DPX-1 SERVICE MANUAL

Service Center Memo: DPX-1 Engineering Changes + Prommer Service Bulletin

DPX-1 Revisions

PRODUCT AFFECTED DPX-1	DRAWINGS/ASSEMBLY AFFECTED DPX-1 5 1/4" Disk Drive - Part #200001	ECO NUMBER 1104
---------------------------	--	---------------------------

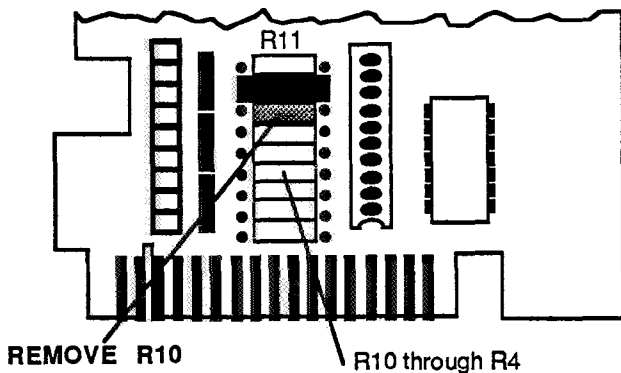
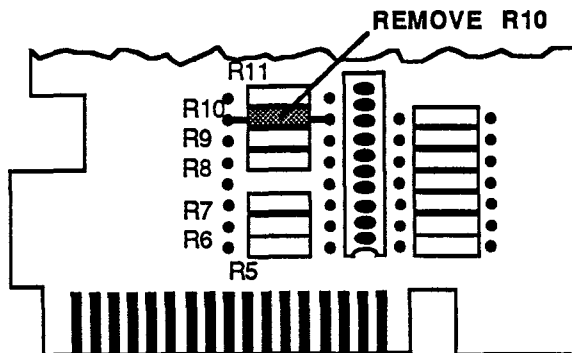
Remove resistor R10 (150Ω) from the 5 1/4" disk drive's PCB according to the instructions below and the accompanying diagrams.

4. Carefully de-solder resistor R10 and remove it from the board. It may then be discarded. Refer to the illustration below for proper identification of this component. The diagrams refer to two different versions of the Toshiba 5 1/4" disk drive. One of these drawings is relevant to the unit you are updating.

PRODUCT AFFECTED DPX-1	DRAWINGS/ASSEMBLY AFFECTED DPX-1 Analog PCB – Part #722210	ECO NUMBER 1105
---------------------------	---	---------------------------

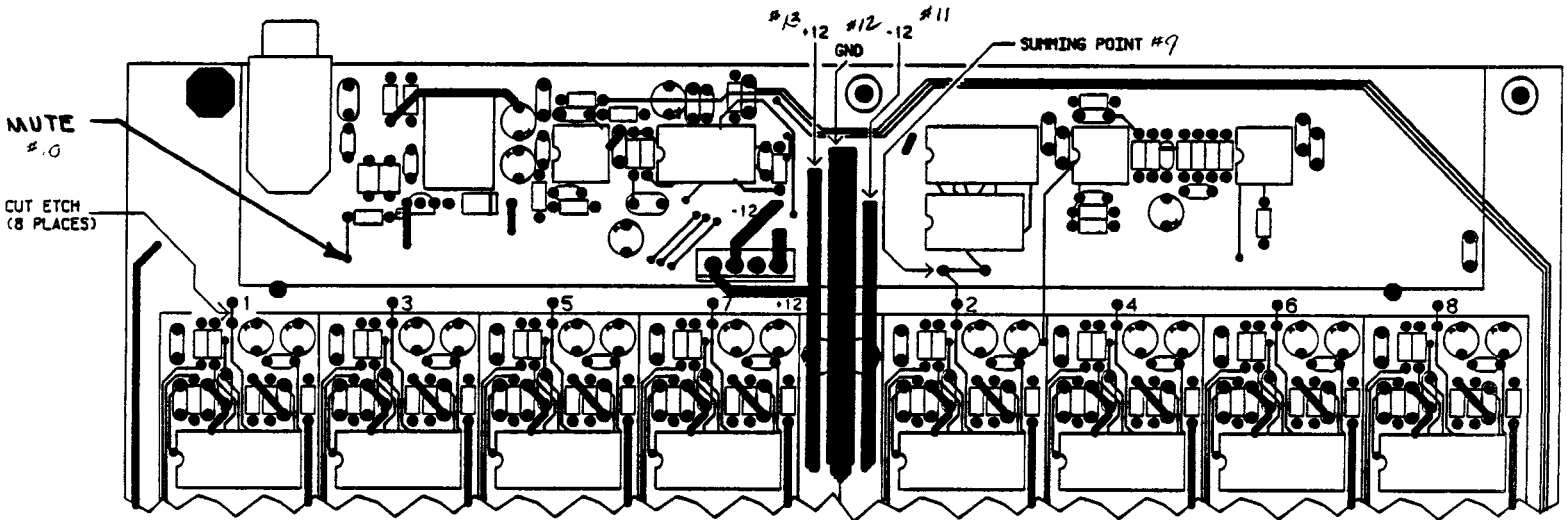
Install 13-conductor cable assembly to DPX-1's analog board according to the instructions and diagram below.

5. Referring to the accompanying diagram, carefully cut the eight (8) printed circuit traces between the two solder pads on each Voice.
6. Solder the 13 leads of the cable assembly according to the accompanying chart. Each solder point exists as a solder pad on the printed circuitry so that each point can soldered cleanly, with no need to remove any of the green masking. When soldering the first eight Voice leads, be absolutely certain that each lead is attached to the pad that is closer to the front of the unit.

Wire Color Coding	Solder Point
8 Voice Leads:	Brown	# 1
	Orange	# 3
	Grey	# 5
	Blue	# 7
	Violet	# 2
	Green	# 4
	Red	# 6
	Yellow	# 8
Summing Point:	White	# 9
Mute Line:	White/Green striped	#10
Power Supply Circuitry:	White/Red striped	#11 (-12 line)
	Black	#12 (ground)
	White/Black striped	#13 (+12 line)

PRODUCT AFFECTED DPX-1	DRAWINGS/ASSEMBLY AFFECTED DPX-1 Analog PCB – Part #722210	ECO NUMBER 1110
----------------------------------	---	---------------------------

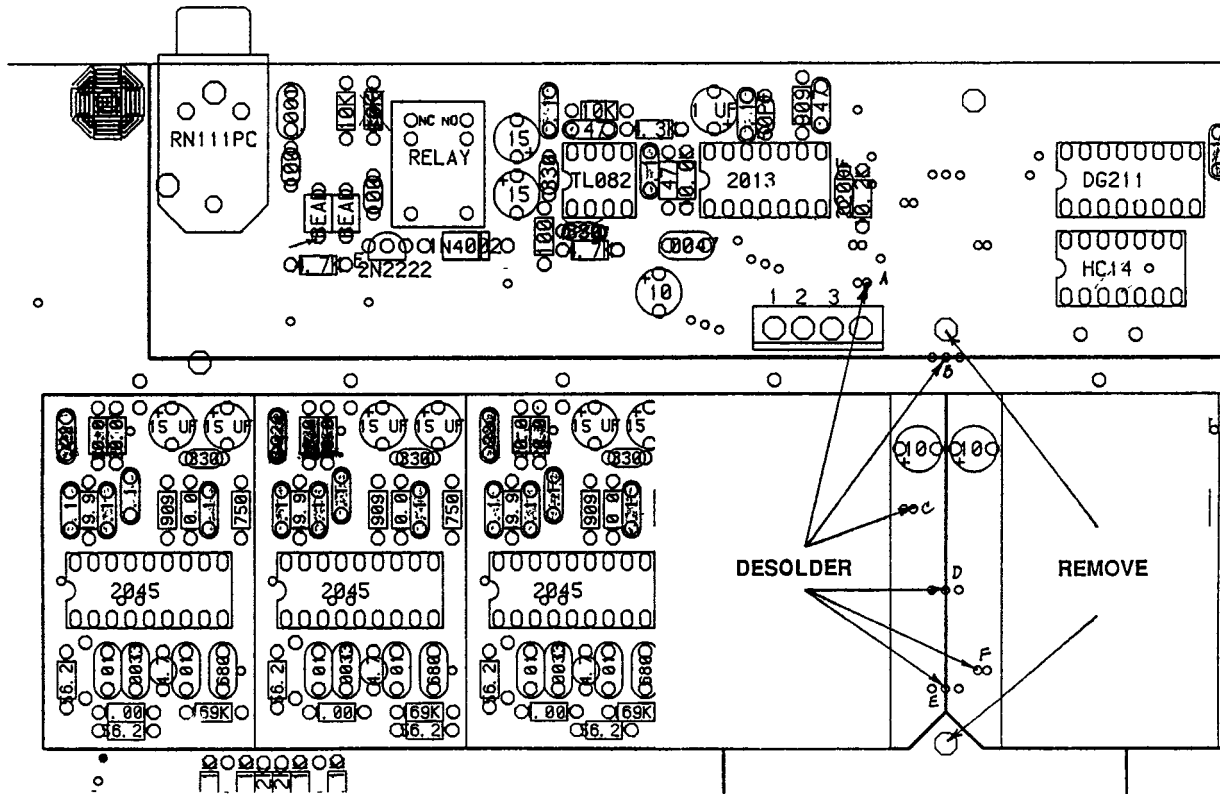
Add two (2) 4700 μ F, 16V radial electrolytic capacitors (Oberheim Part #151072) and one (1) 4700 μ F, 6.3V radial electrolytic capacitor (Oberheim Part #151073). Refer to the diagrams below and on the next page, following the accompanying procedure.

11. Turn the analog board over again, exposing its component side. Referring to the diagram above, install the three electrolytic capacitors according to the following chart:

CAPACITOR VALUE	POSITIVE LEAD	NEGATIVE LEAD
4700 µF, 6.3V	Feed through "A"	Feed through "B"
4700 µF, 16V	Feed through "C"	Feed through "D"
4700 µF, 16V	Feed through "E"	Feed through "F"

NEW:

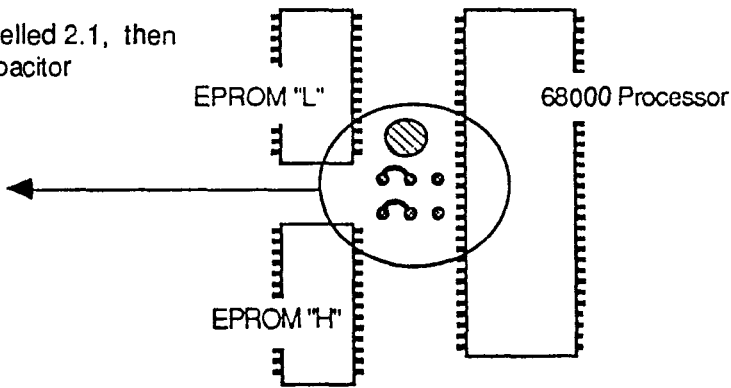
3. If the two 28-pin EPROMs are not labelled 2.1, then re-position the Jumper adjacent to capacitor C409 according to the diagram.

FIG. 1: One of three HFO circuits as depicted in the Matrix-6 Voice Board Schematic, Sheet 2 of 3.

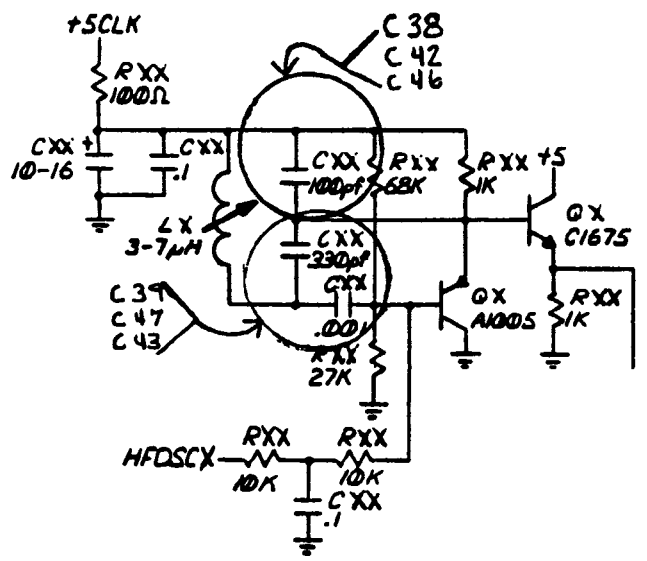
1. Replace C38, C42 and C46 with 100 pF silver mica, 5% capacitors (Oberheim Part #157066).
2. Replace C39, C43 and C47 with 330 pF silver mica, 10% capacitors (Oberheim Part #157035).
3. After replacing all six capacitors, the HFOs must be recalibrated as described on Page 4 of the Matrix-6 Service Manual.

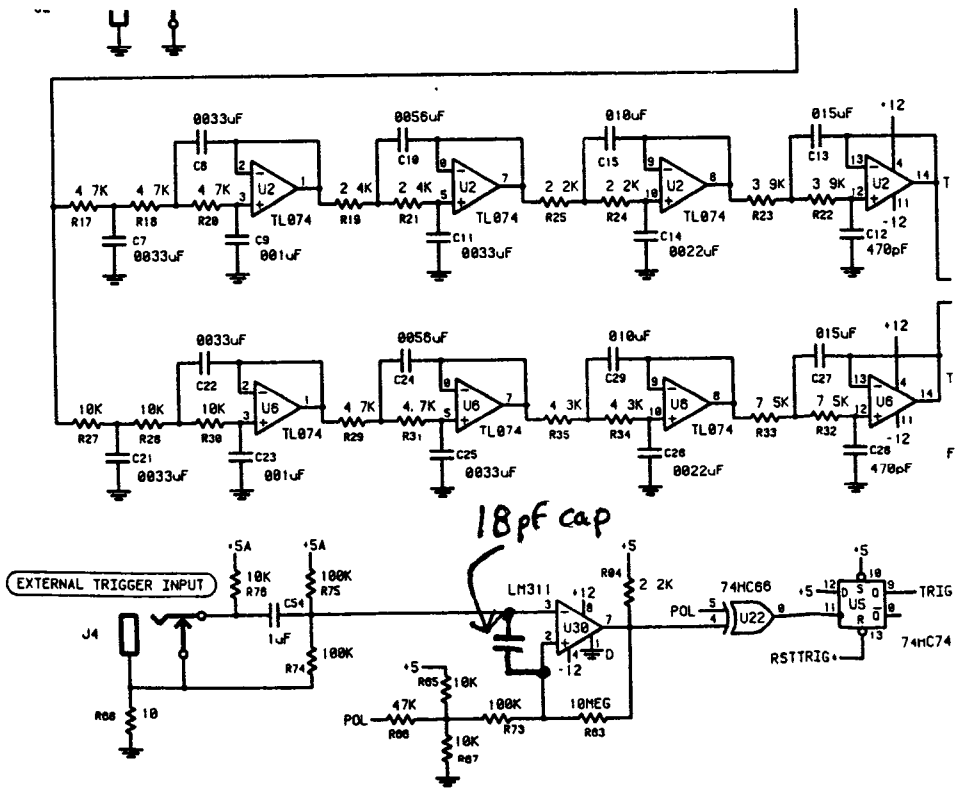
Add 18pF, 100V ceramic disk capacitor (Oberheim Part #157036) directly to U30, pin 2 and pin 3, as shown below:
